Village of Grantsburg

Village Board Meeting Agenda Monday, February 9, 2026 at 4:00 p.m. Village Board Room, 316 S. Brad Street

RE: Change Order 01
Village of Grantsburg
Grantsburg WWTP Improvements
SEH No. 184139 71.50

Change Order No. 1 to the Grantsburg WWTP Improvements project is enclosed. This Change Order includes six (6) items previously approved as individual line items by the Village Board and two (2) items that have not been approved. SEH recommends approval of Change Order No. 1 to incorporate the following changes into the Contract with Market & Johnson, Inc. (Contractor):

REVISION SCHEDULE		
REV. #	DESCRIPTION	DATE
1	FIELD ORDER #5	10/08/2025

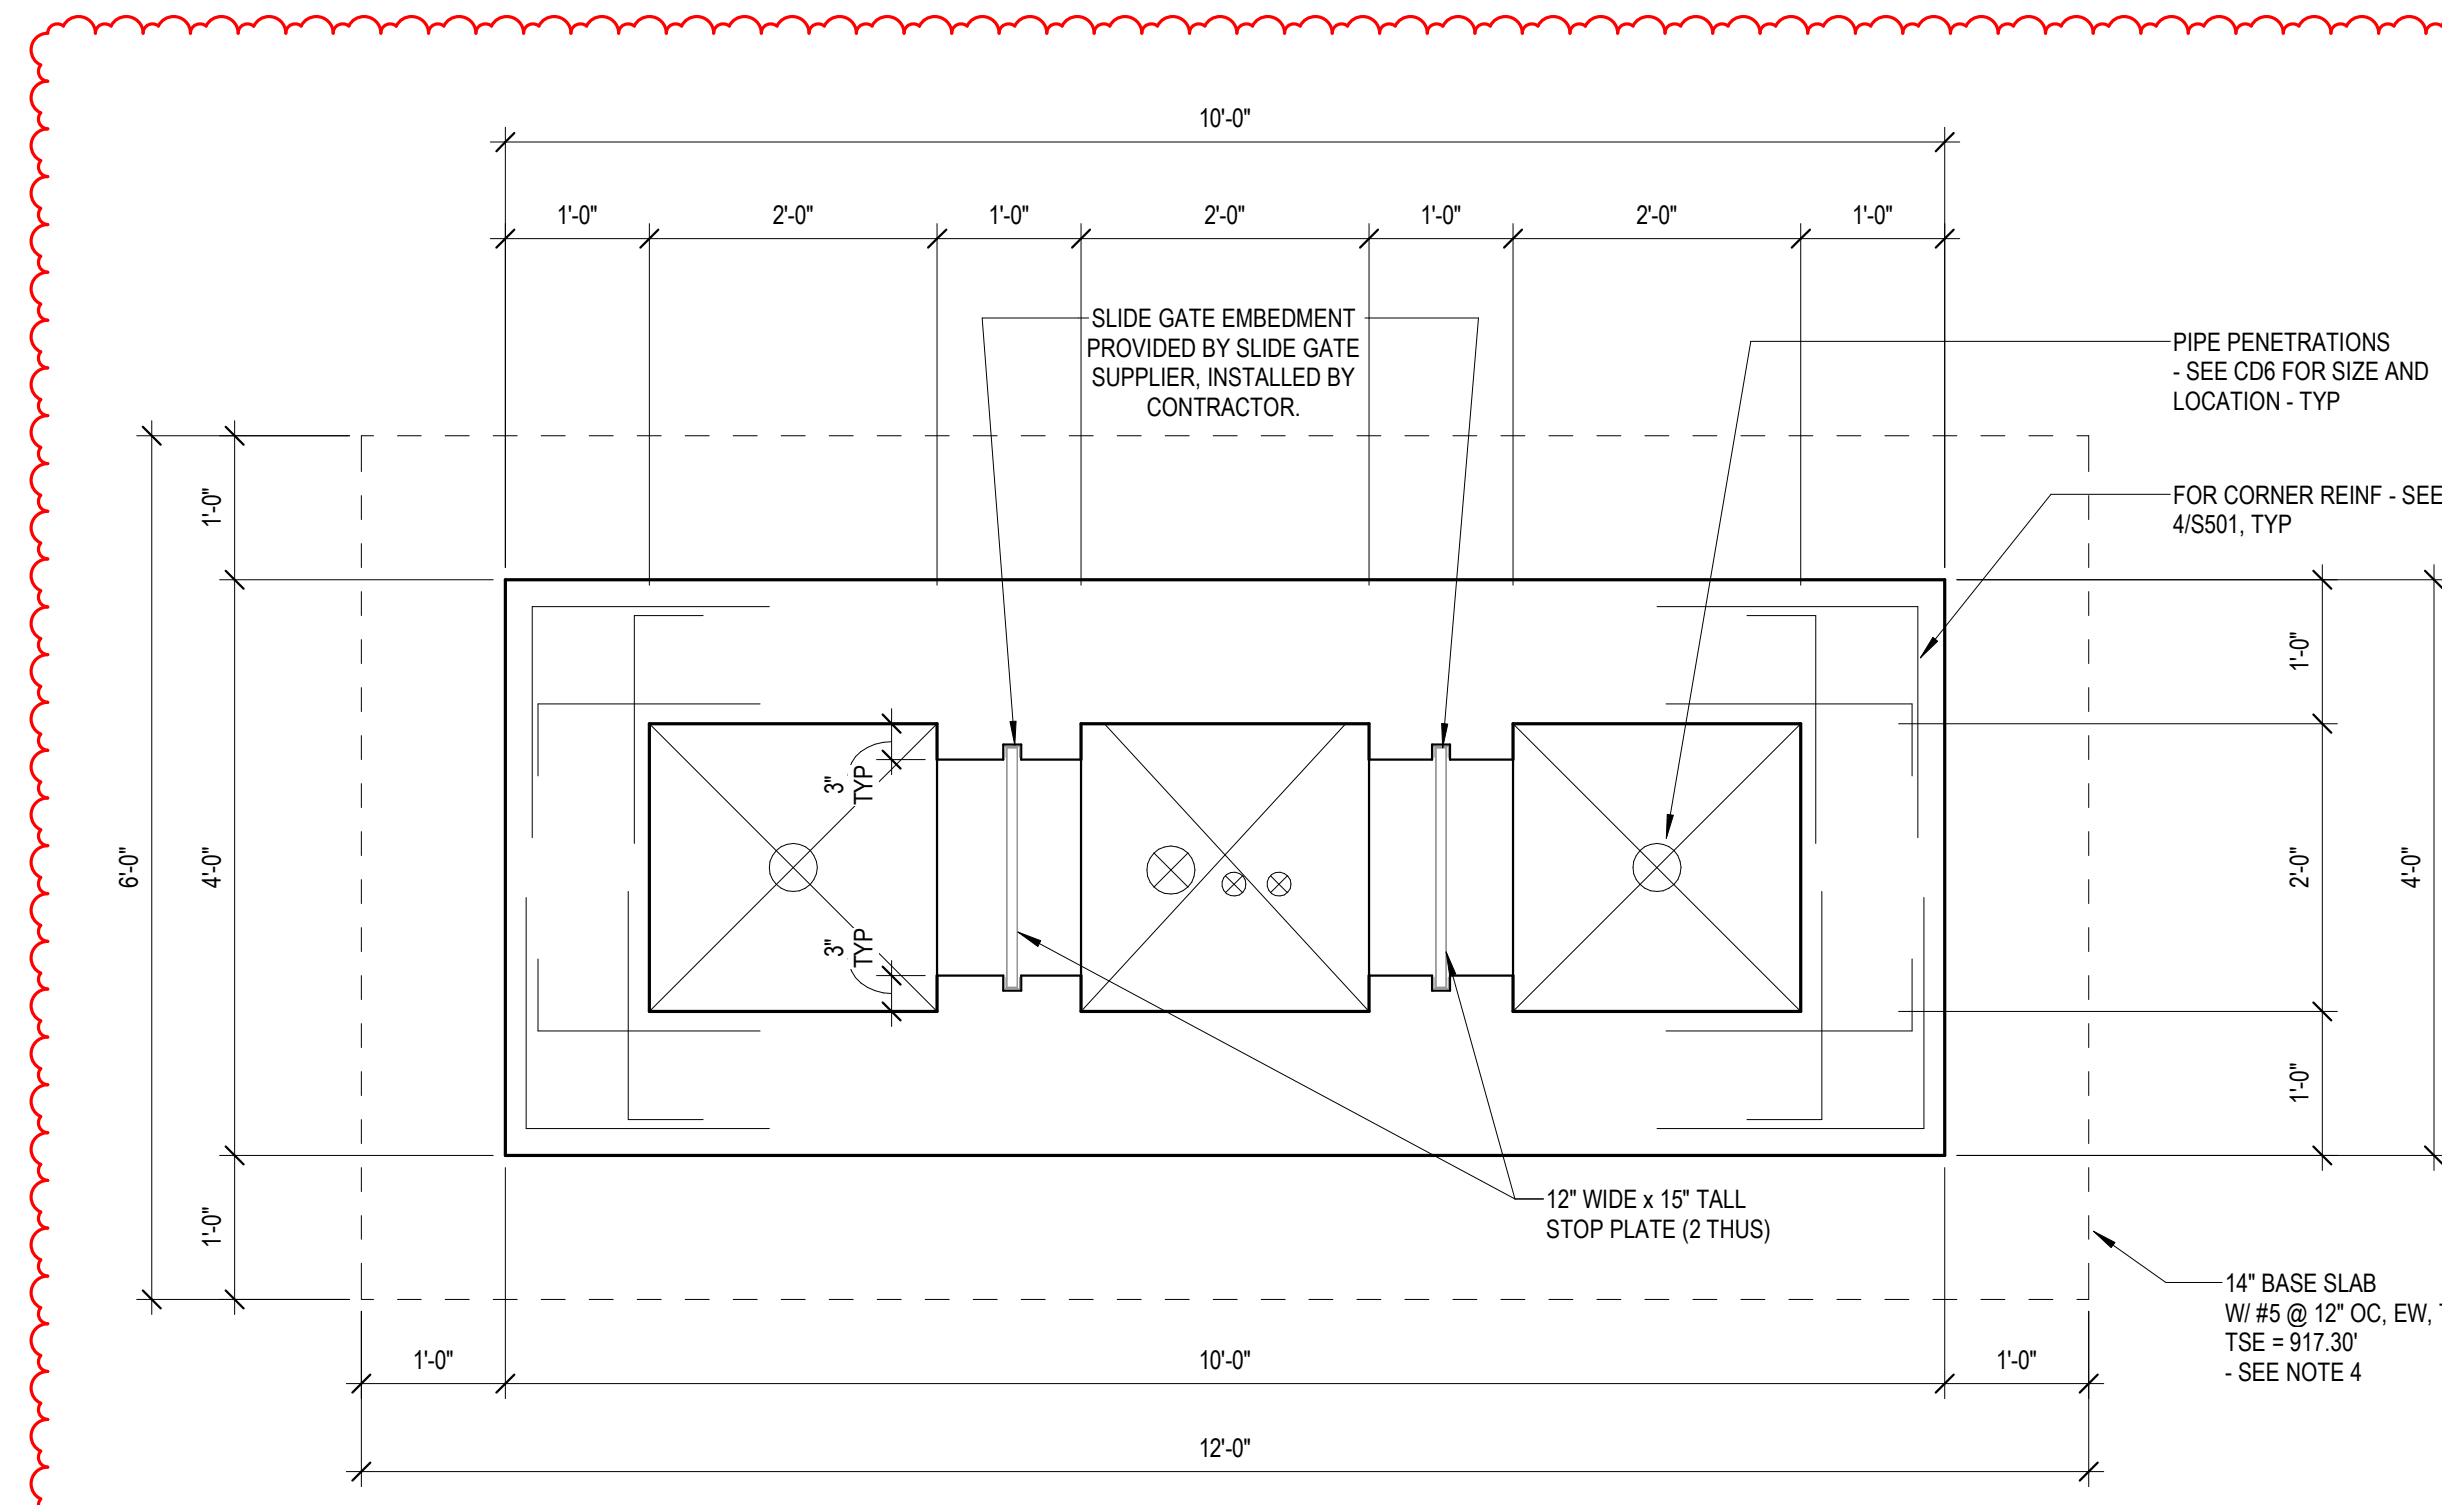
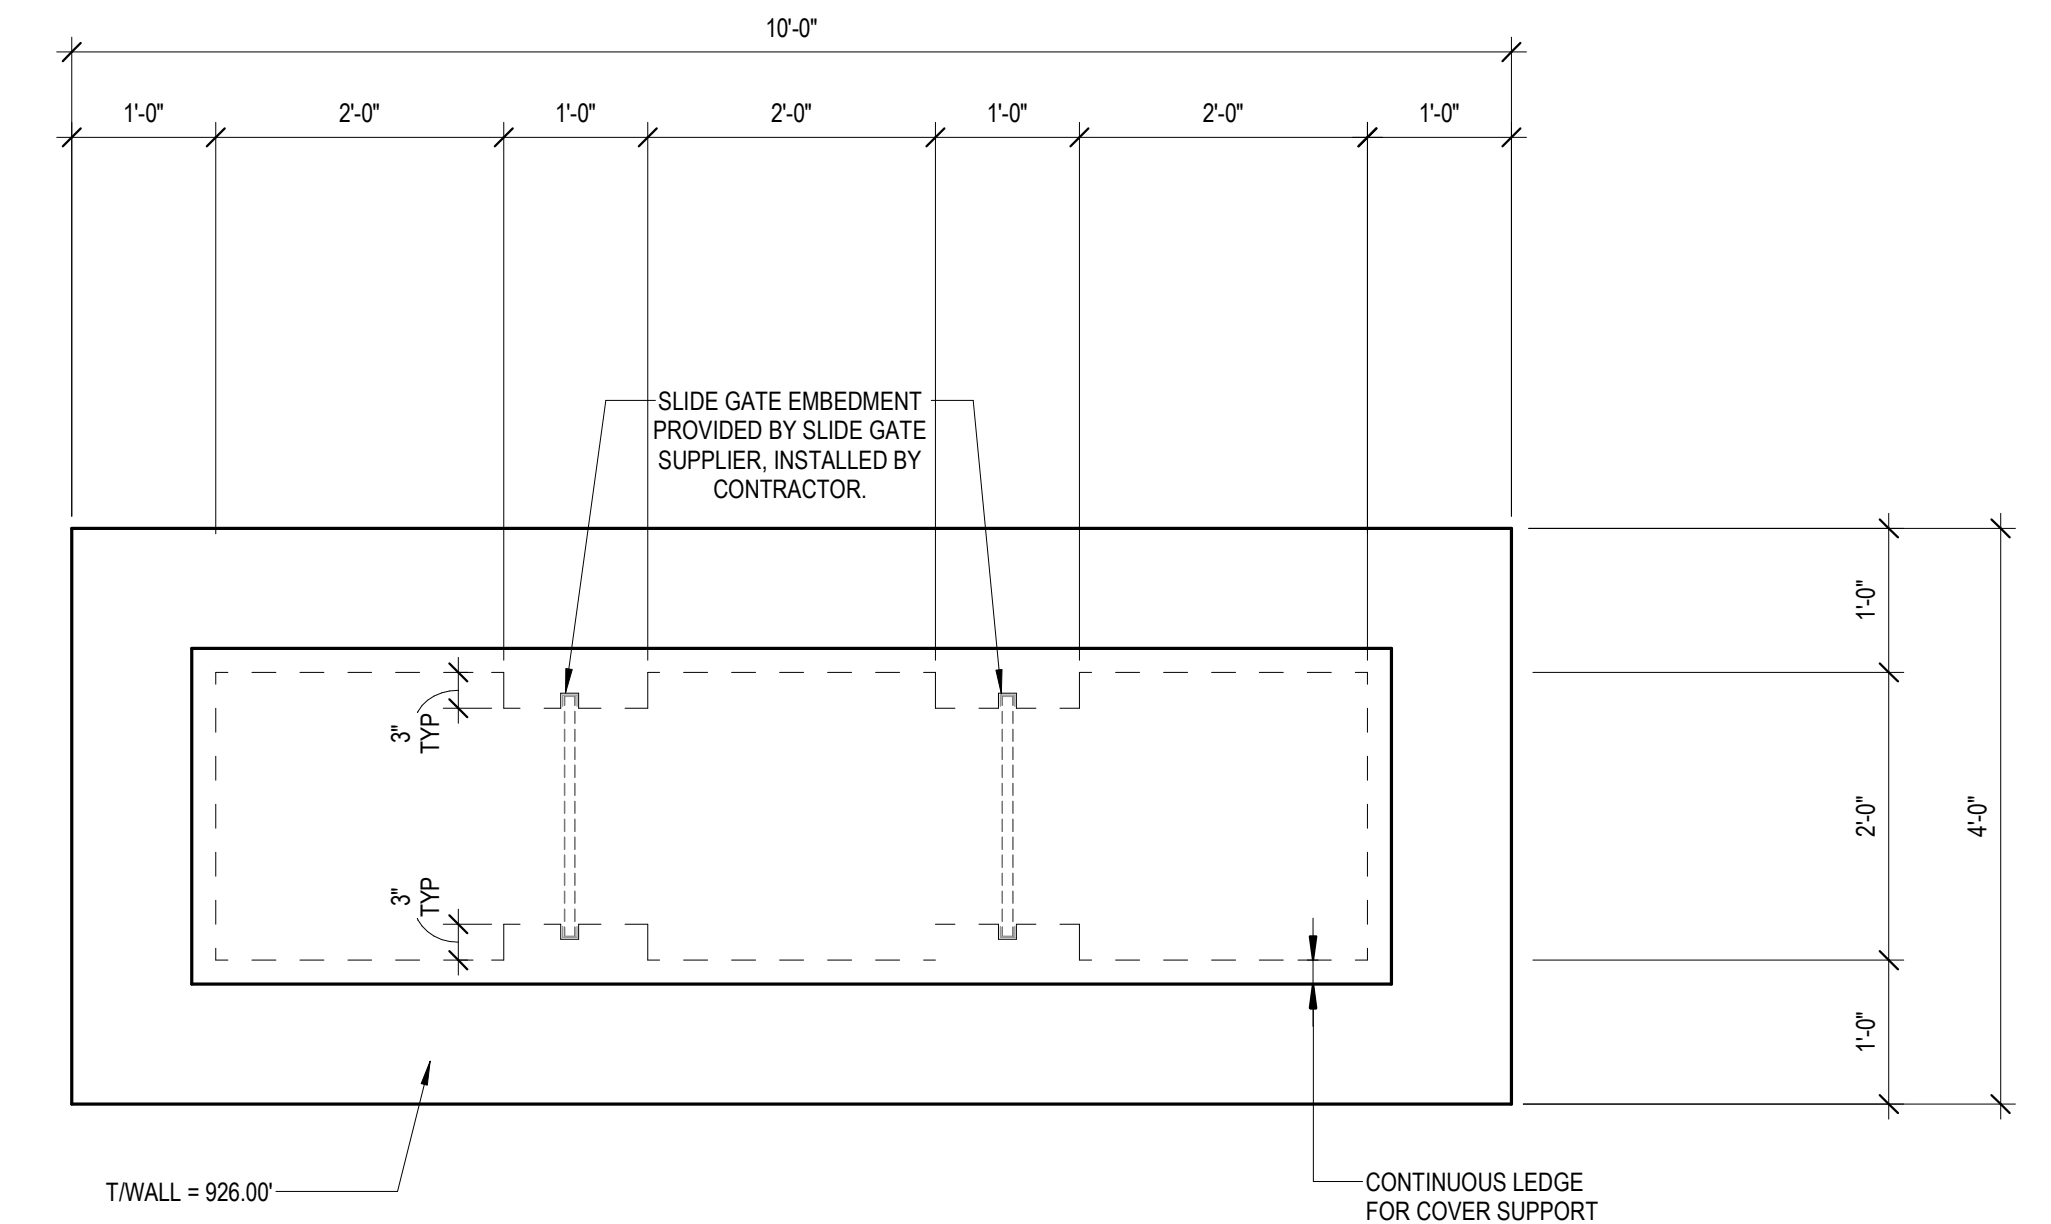
- Change Order Request #07 – Splitter Box Dimension Clarifications (FO #5)**
 Dimensional adjustments result in no change in contract price or time; COR #7 is recommended for approval. This change was approved by the Grantsburg Village Board on December 8, 2025.
